UNITED STATES
ATOMIC ENERGY COMMISSION
WASHINGTON, D.C. 20545

DML:CEM
70-337
SNM-338, Amendment No. 71-34 ✓

LICENSE AMENDMENT
for
DELIVERY OF SPECIAL NUCLEAR MATERIAL
to a
CARRIER FOR TRANSPORT

LICENSEE	
1. Name: Westinghouse Electric Corporation	3. License No. SNM- <u>338</u>
2. Address: 3 Gateway Center Box 2278 Pittsburgh, Pennsylvania	Amendment No. <u>71-34</u>
	4. Docket No. <u>70-337</u>

Figure 1

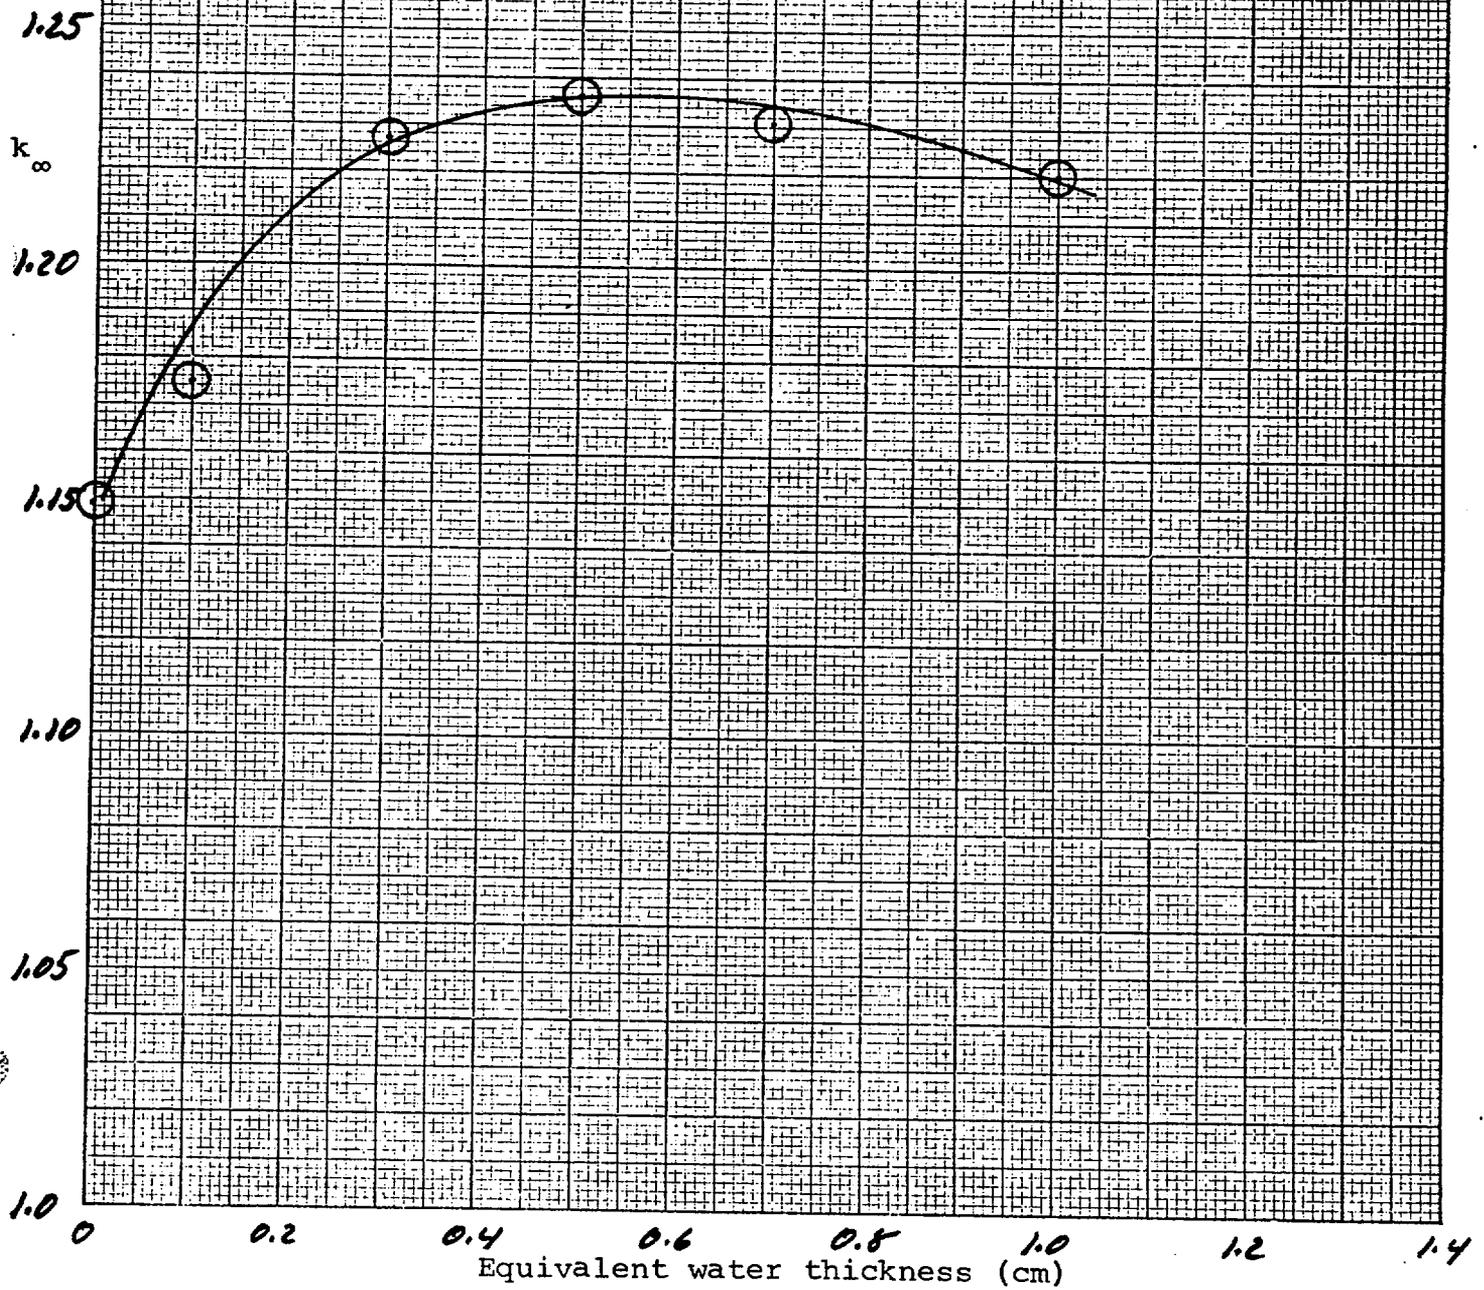
18	5/21/68	48.1	Added
18	5/21/68	49	Specified absence of moderation as an undamaged package parameter. Referenced Fig. 2
18	5/21/68	Appendix L	Added Figures 1 and 2.

Package Array Evaluation - In view of the ability of these packages to exclude water after being subjected to the hypothetical accident conditions, the array is evaluated by considering that optimum interunit water moderation is present between dry UO_2 packages. The following parameters were used to carry out array calculations using the ANISN and KENO codes,^{/1} assuming optimum interunit moderation as determined in the course of the calculations. The results of the ANISN calculations are shown in Figure 1 of Appendix L.
